Office Action Summary	Application No. 10/509,075	Applicant(s) DONATH, RAOUL	
	Examiner Nicholas Woodall	Art Unit 3733

DETAILED ACTION

Figure 1

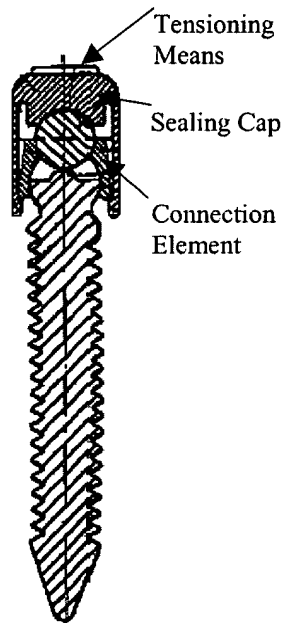
Regarding claim 1, Schaffler-Wachter discloses a device comprising a connection element, a sealing cap, and a tensioning means as shown in Figure 1 below. The connection element, as shown in Figure 2, is arranged coaxially to the central axis with an upper end, lower end, a channel passing through the connection element transversely to the longitudinal axis, and a cavity coaxial to the central axis passing through the connection element from the upper end to the lower end. The cavity is designed tapering towards its lower end by means of at least one shoulder as shown in Figure 3. The sealing cap, as shown in Figure 4, comprises a front end, rear end, a second cavity to receive the connection element, and a second channel transverse to the longitudinal axis. Regarding claim 2, Schaffler-Wachter discloses a device characterized the arresting means of the latching means is arranged on a cross-section surface orthogonal to the central axis on the periphery of the connection element and on the periphery of the second cavity in the sealing cap as shown in Figure 2. Regarding claim 3, Schaffler-Wachter discloses a device characterized in that the arresting means is comprised of a bulge on the external periphery of the connection element and a corresponding recess on the inner periphery of the second cavity in the sealing cap as shown in Figure 3. Regarding claim 4, Schaffler-Wachter discloses a device

Figure 3

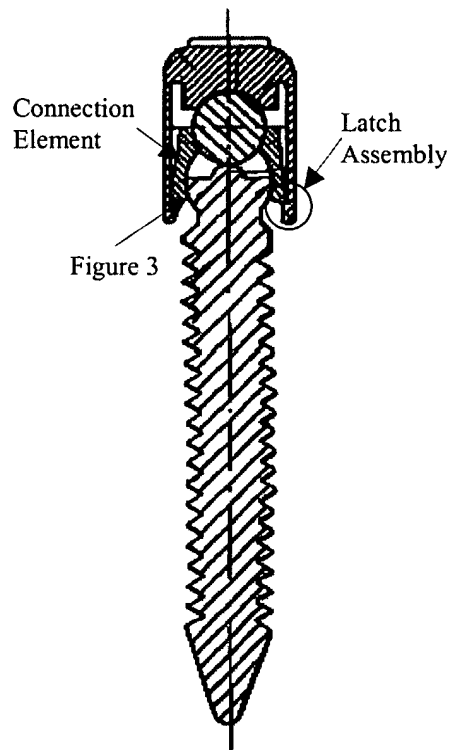
characterized in that the shoulder in the connection element comprises a level-bearing surface of a circular shape concentric to the central axis as shown in Figure 3.
